## ADDENDUM #5

**Western Slope Food Bank of the Rockies**  
698 Long Acre Drive

**Bid Package #4 – Above Ground**

September 10, 2021

PROJECT NO: 2108 **A403**

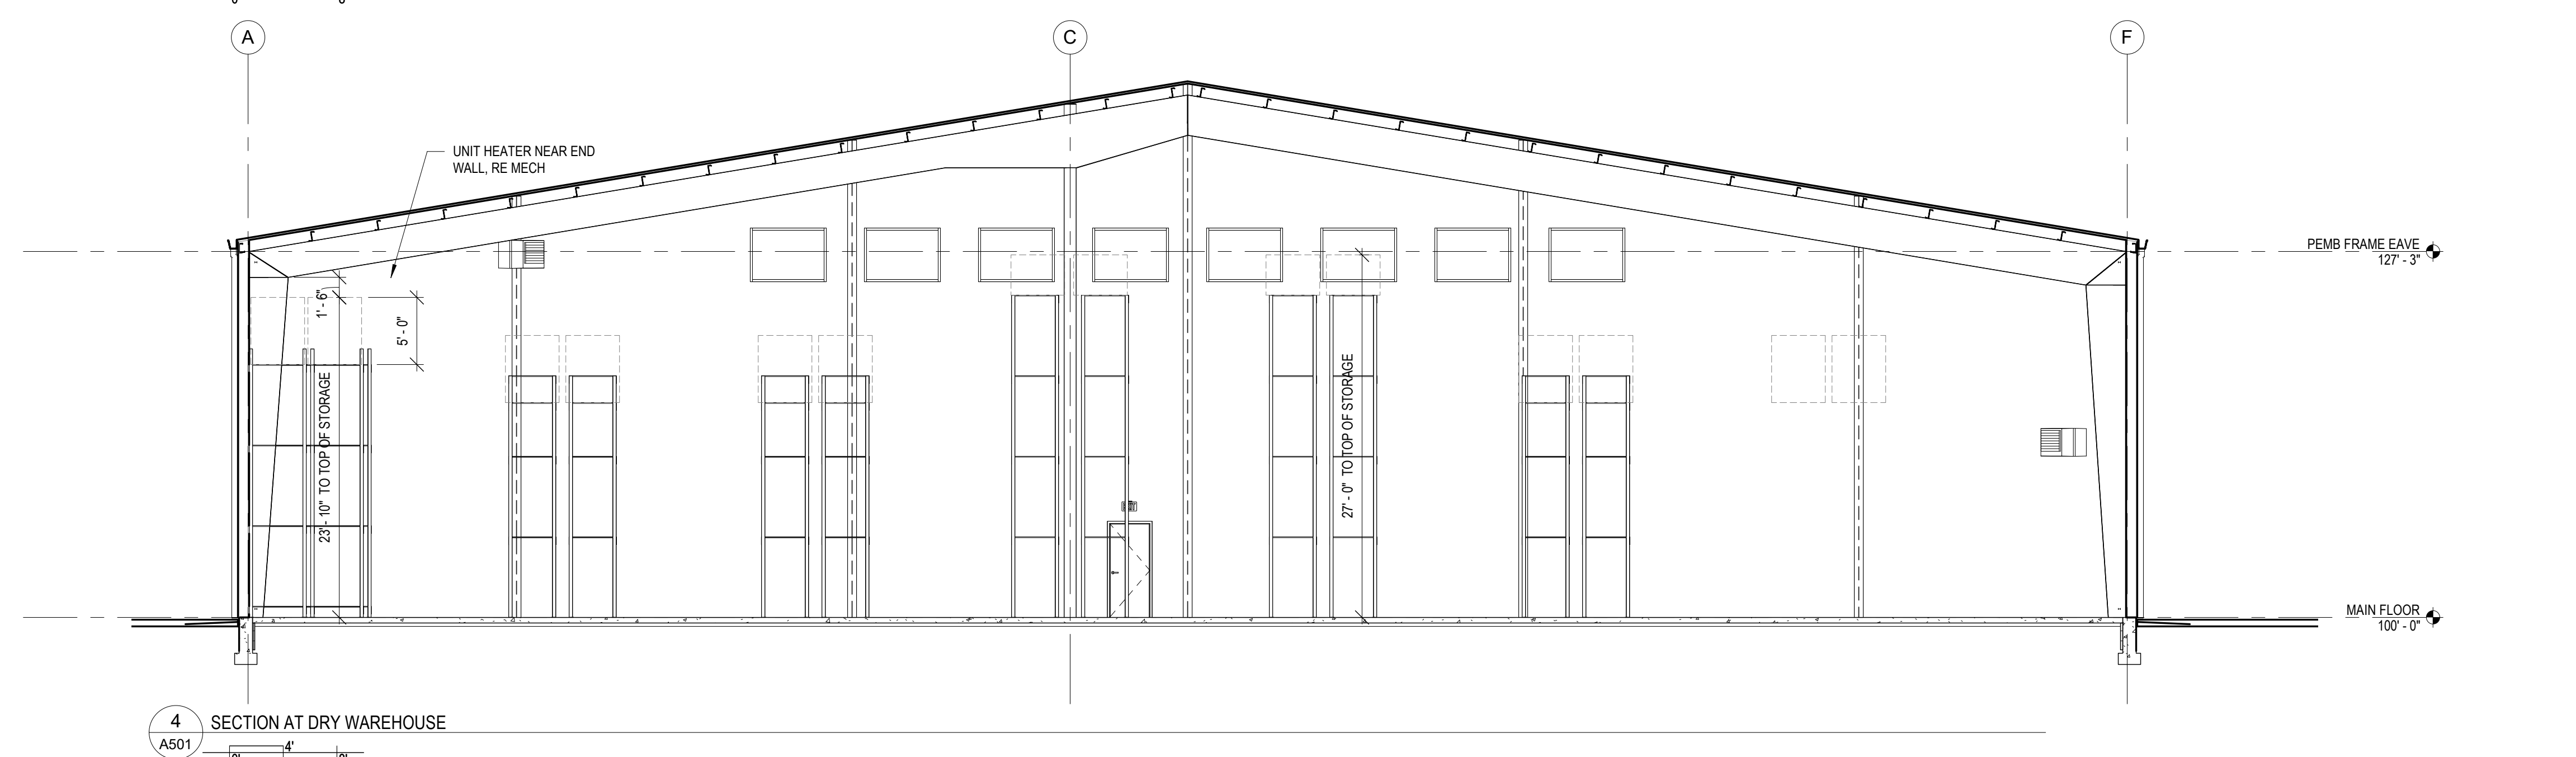
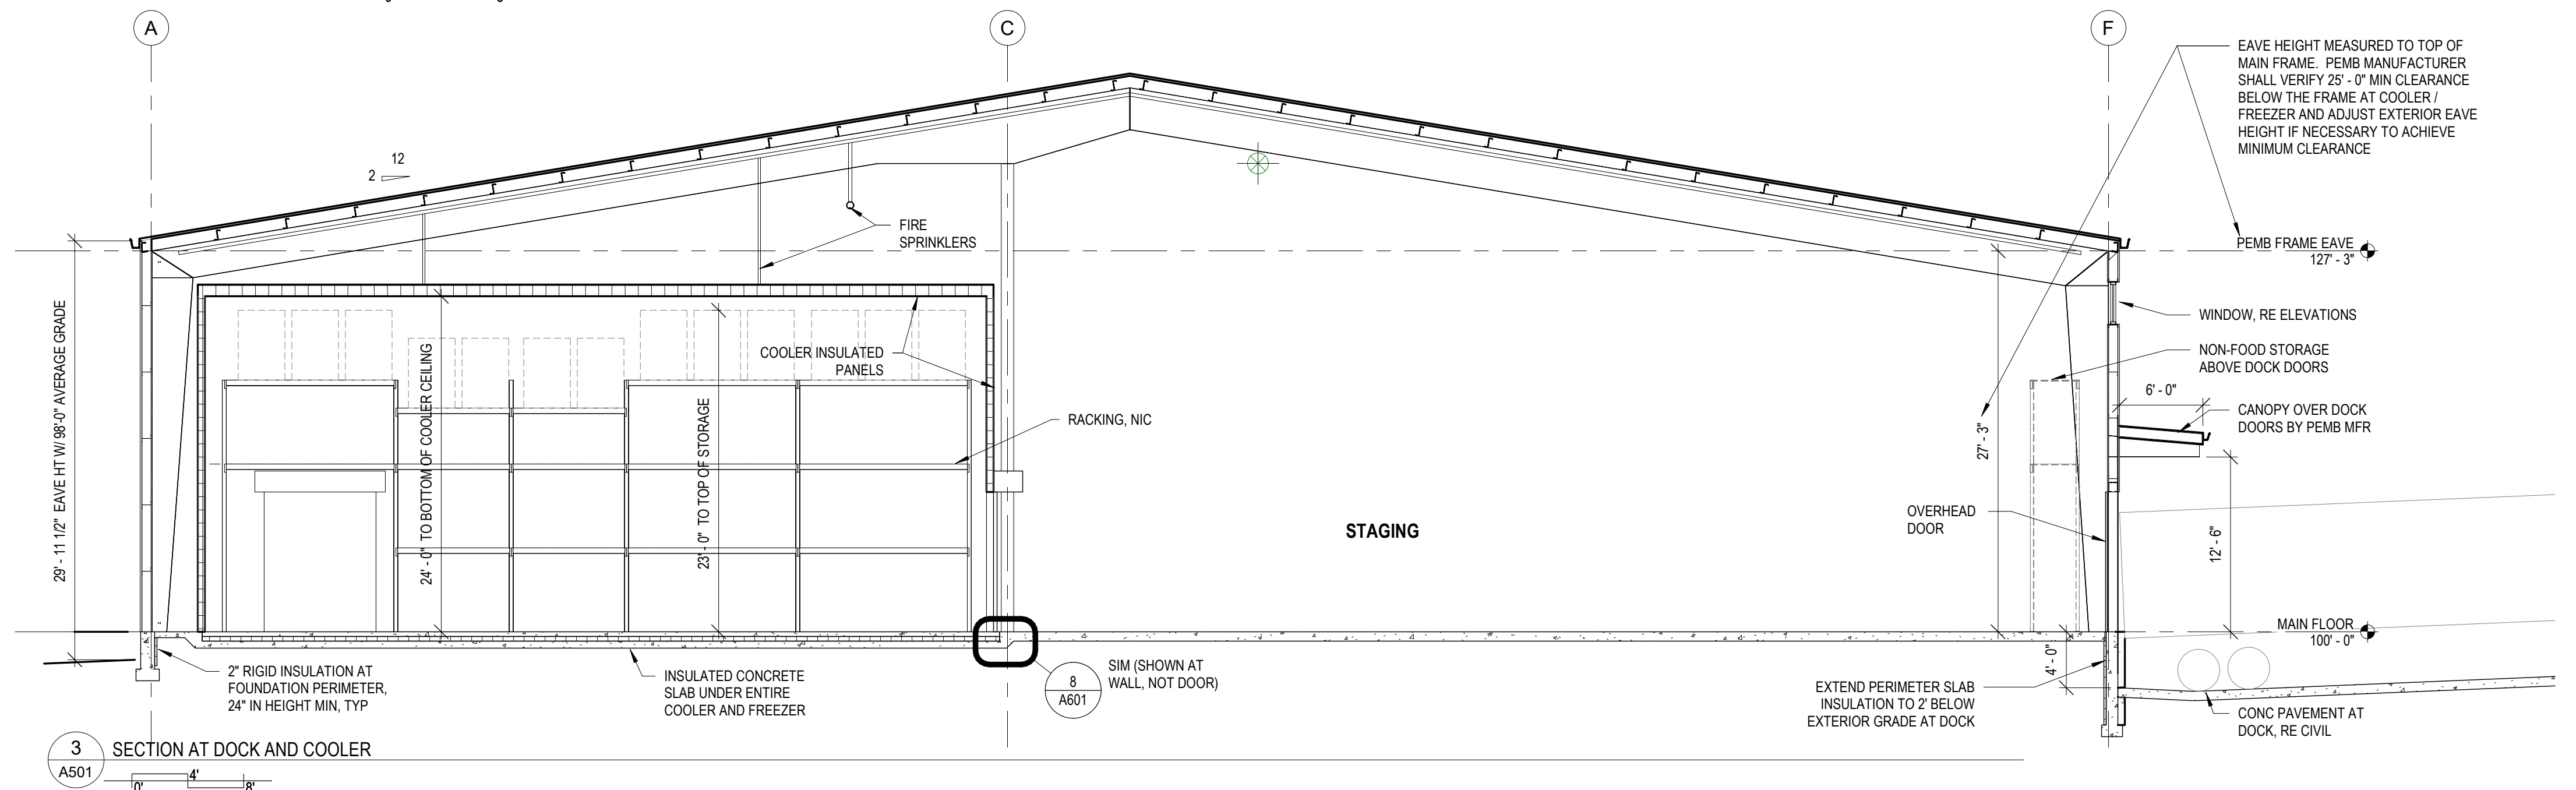
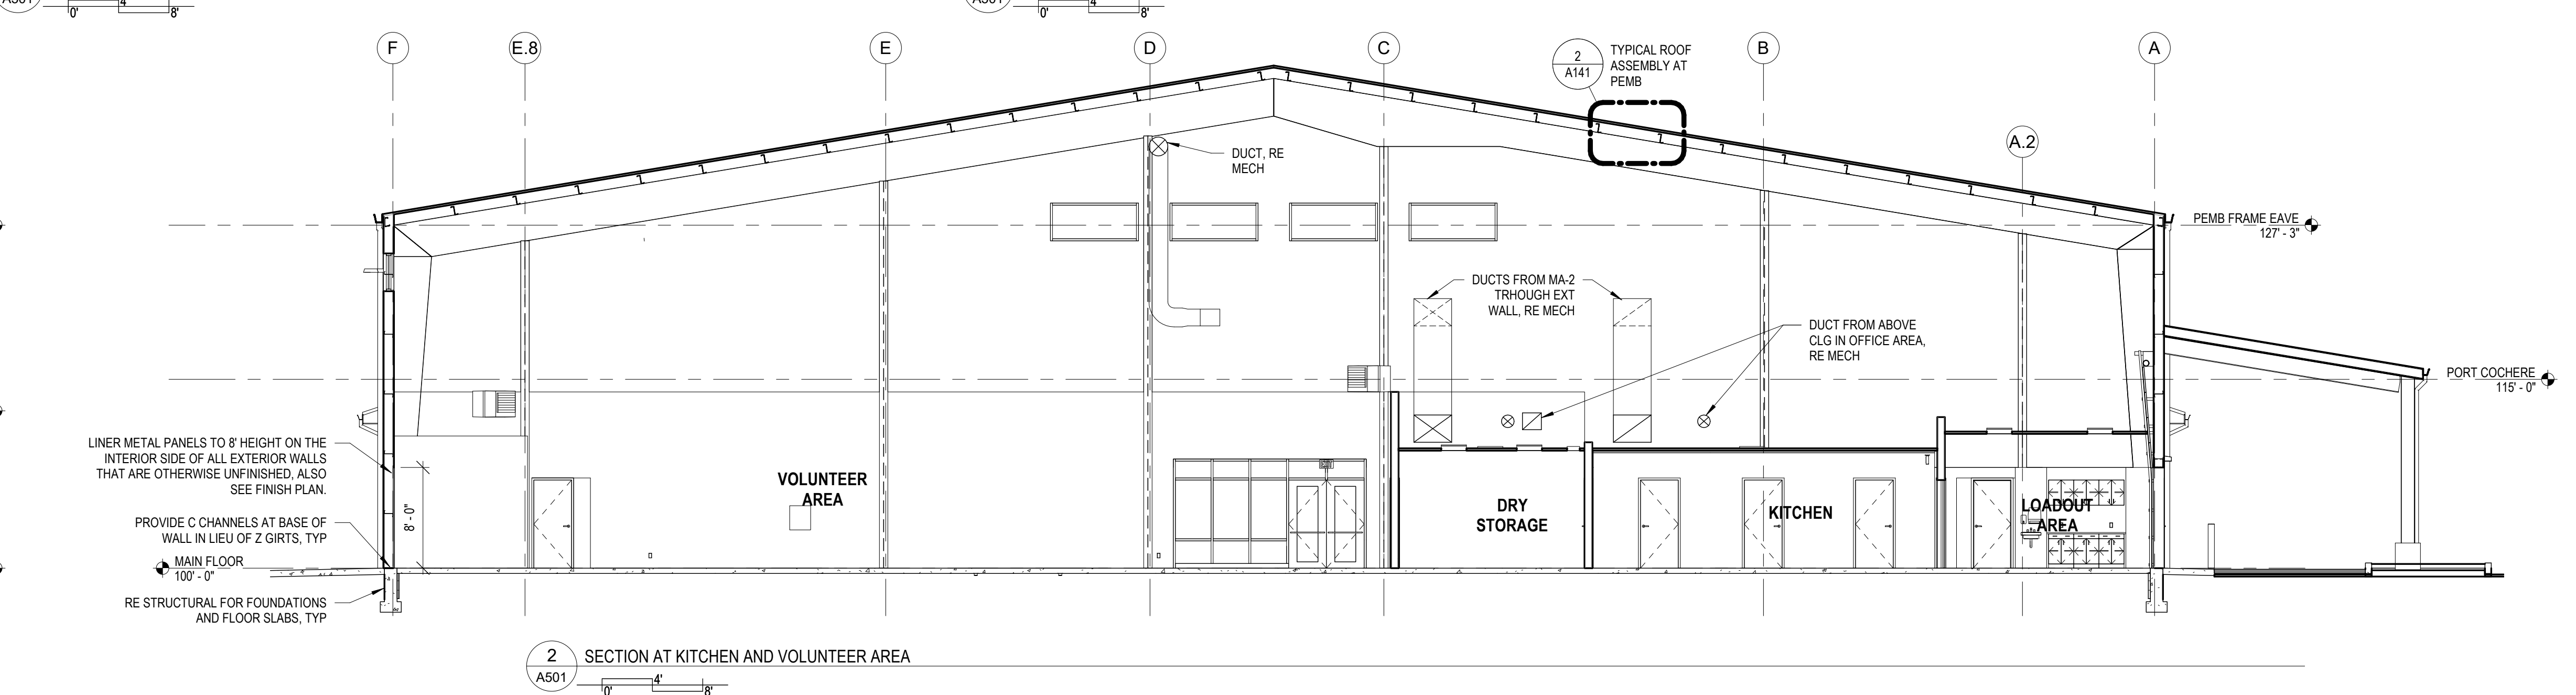
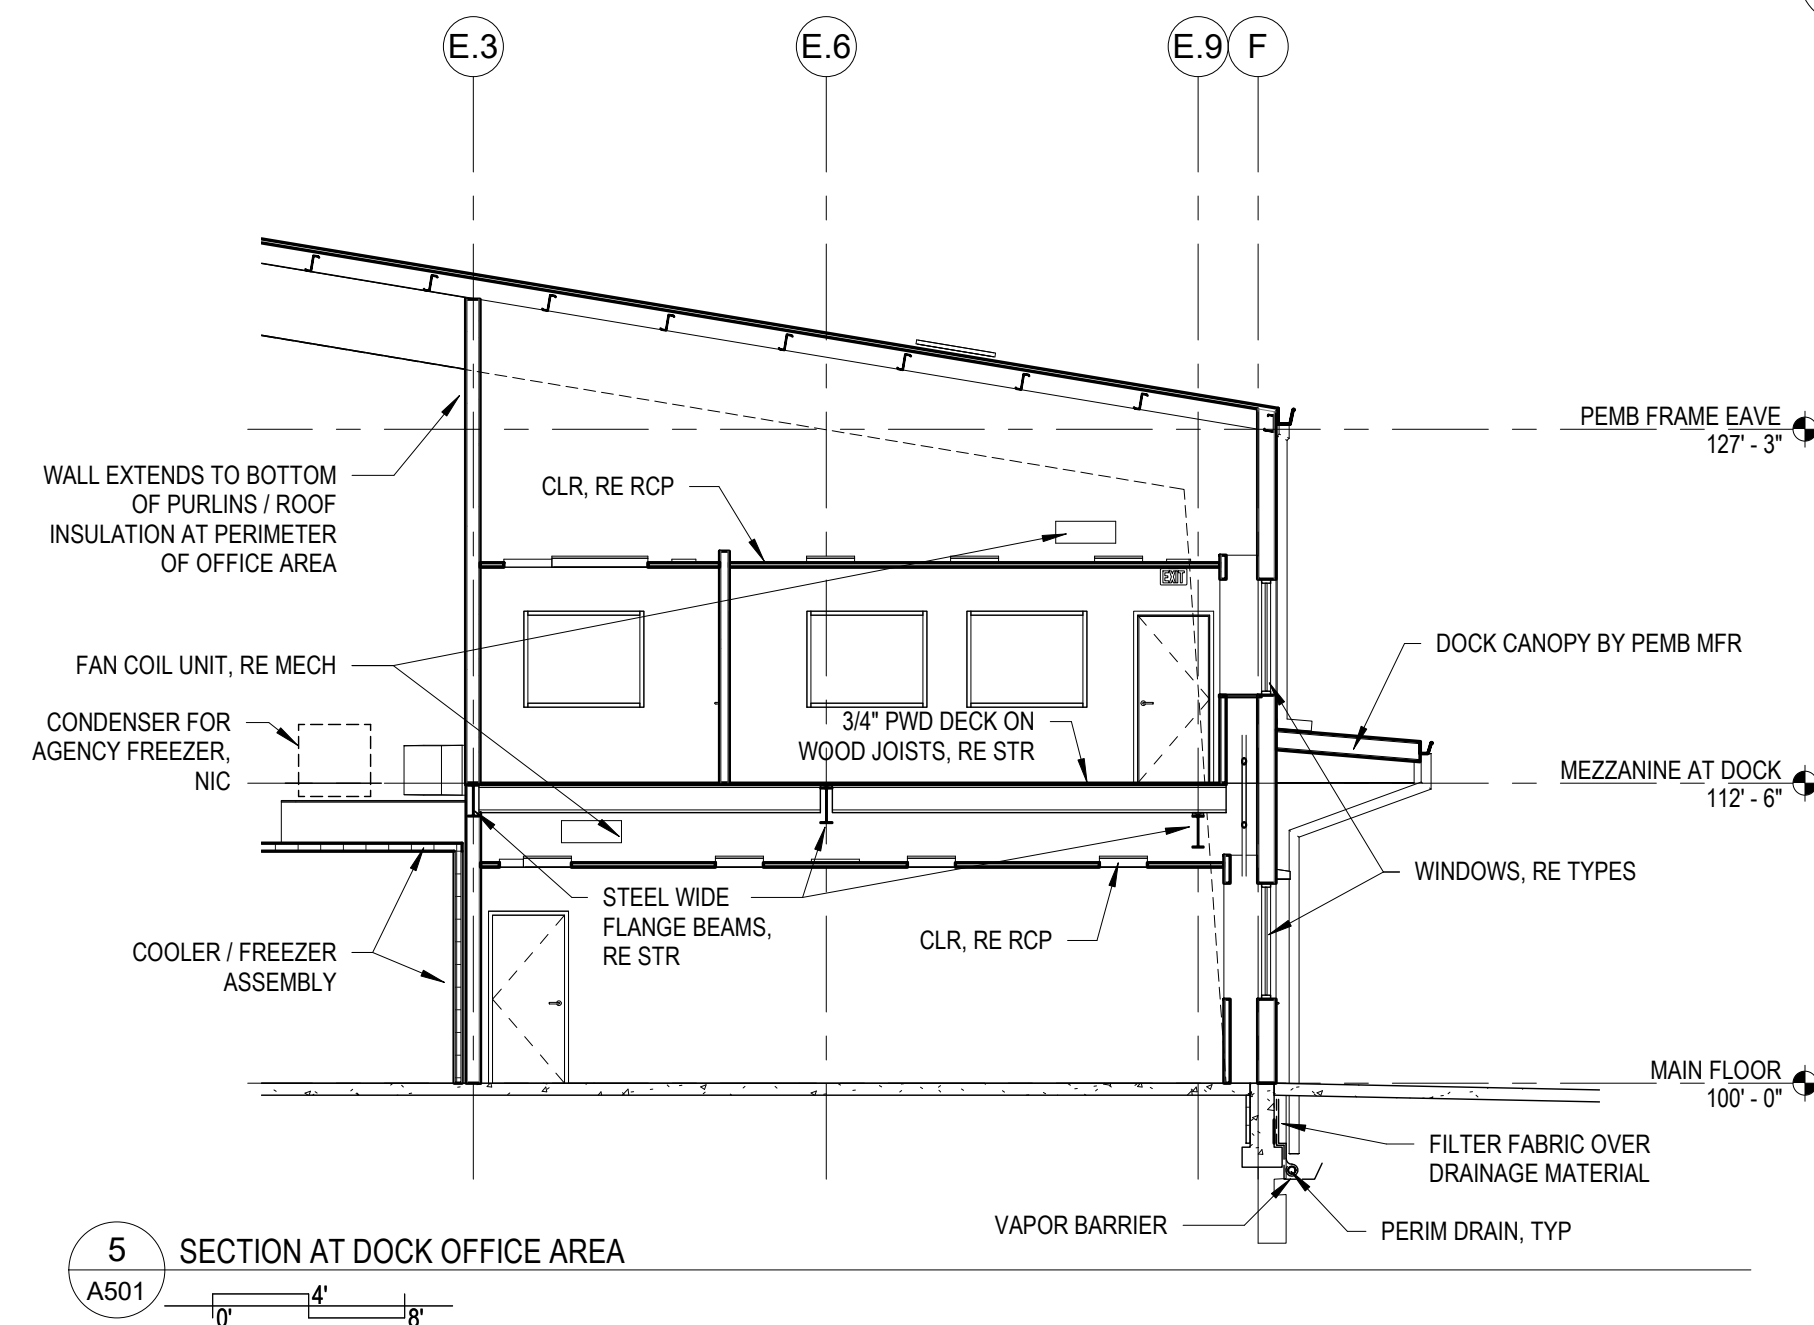
- ADD5-17 Sheet A403 Interior Elevations: Delete sheet and replace with attached revised sheet A403.
- ADD5-18 Sheet A501 Building Sections: Change detail 1 per attached revised sheet A501.
